# Technical Service Bulletin

SUBJECT:		No:	<b>TSB-25-17-001</b>
<b>IN-CABIN FUEL SMELL WHEN VEHICLE IS IDLING OR BEING DRIVEN</b>		DATE:	<b>April 2025</b>
		MODEL:	<b>See below</b>
<b>CIRCULATE TO:</b>	<input type="checkbox"/> GENERAL MANAGER	<input checked="" type="checkbox"/> PARTS MANAGER	<input checked="" type="checkbox"/> TECHNICIAN
<input checked="" type="checkbox"/> SERVICE ADVISOR	<input checked="" type="checkbox"/> SERVICE MANAGER	<input checked="" type="checkbox"/> WARRANTY PROCESSOR	<input type="checkbox"/> SALES MANAGER

Figure 11 : Bottom view / Disconnect vent hose and vent pipe

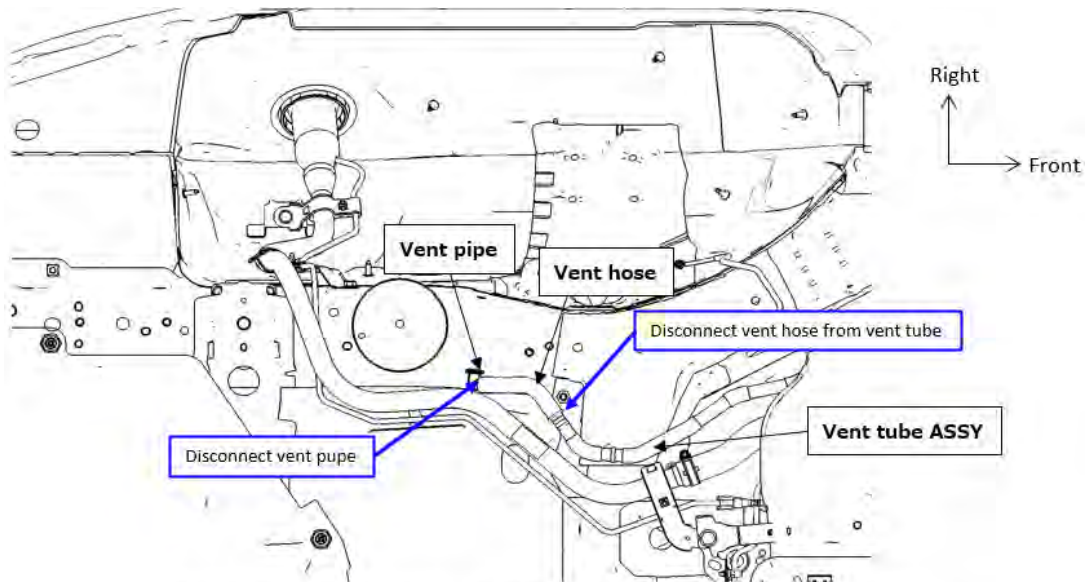
Fuel evaporation may cause a fuel smell to be present inside the vehicle cabin while the vehicle is idling or being driven. This is a result of the canister vent positioned on a side-member that is connected to the vehicle cabin. The concern is resolved by changing the structure of the vent pipe and positioning it to the rear wheel house.

8. Disconnect vent pipe and vent hose.
  - Remove vent pipe fixing on side member (Figure 11)
  - Disconnect vent hose from vent tube assembly (Figure 11)

Figure 14 : Filler tube COMPL

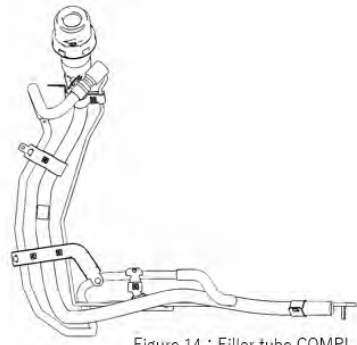
- Replace filler tube COMPL (Figure 14, 15)
- For installation position and tightening torque of filler tube COMPL refer to the Service Manual, Engine - Fuel System, Fuel Tank (removal/installation of the fuel tank is not necessary)
- Connect filler tube COMPL and filler hose (Figure 16)
- Connect filler tube COMPL and vent tube (Figure 16)
  - Yellow mark on vent hose should be set facing the underside of the vehicle (Figure 16)
- Reference TSB-23-13-005
